7. Hydrology/hydraulics and surface water quality

A summary of the comments received during the JRYUP EIS consultation process relevant to hydrology/hydraulics and surface water quality issues are outlined below.

Figure 7.1 (previously EIS Figure 7.1) shows all relevant monitoring sites proximal to the study area.

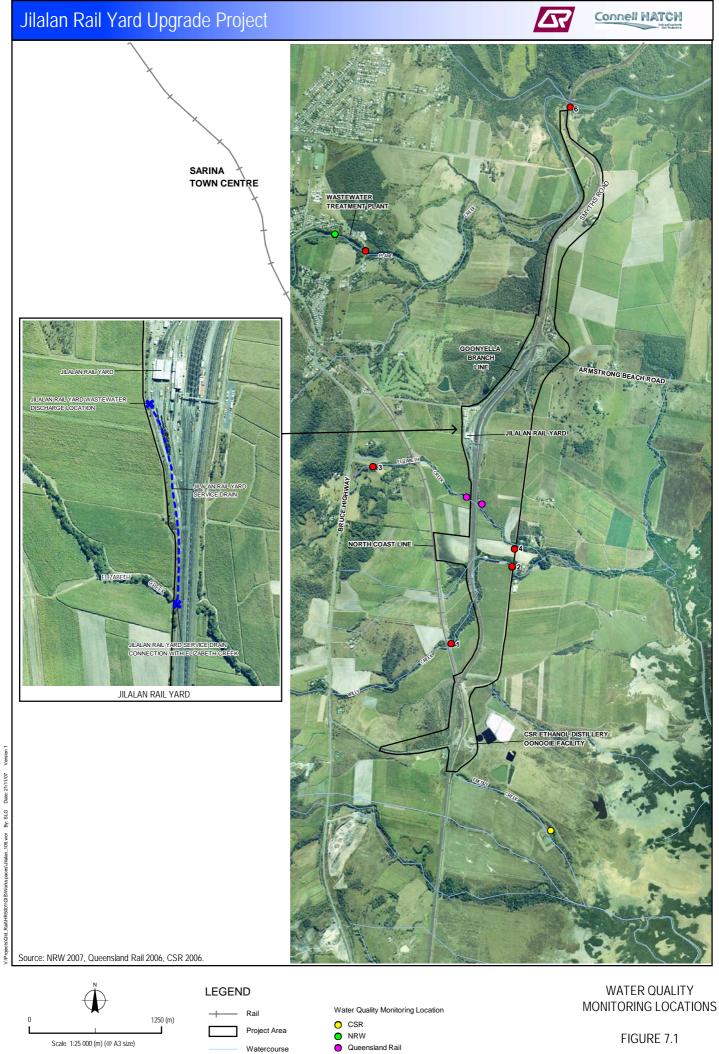
- Further details required on stormwater management during construction.
- Requirement to consider the use of baseline data collated by the Department of Natural Resources and Water (NRW) for Plane Creek.
- Request to include additional information (ie metadata) to support the monitoring data used in the EIS.
- Commitment required to continue collection of baseline data until the construction period commences.
- Clearer definition for the event-based sampling monitoring program.

Ambient data for Plane Creek at Sarina (at the weir downstream of the Bruce Highway) has been provided by NRW. The data provided by NRW consists of samples collected at approximately monthly intervals commencing 18 July 2006, with the most recent data recorded on 13 June 2007. This data has been incorporated into the baseline data set included in the SEIS (refer Table 7.1).

Further to this, additional data has been sourced from QR for Elizabeth Creek and this has also been incorporated into the baseline data set (refer Table 7.2)
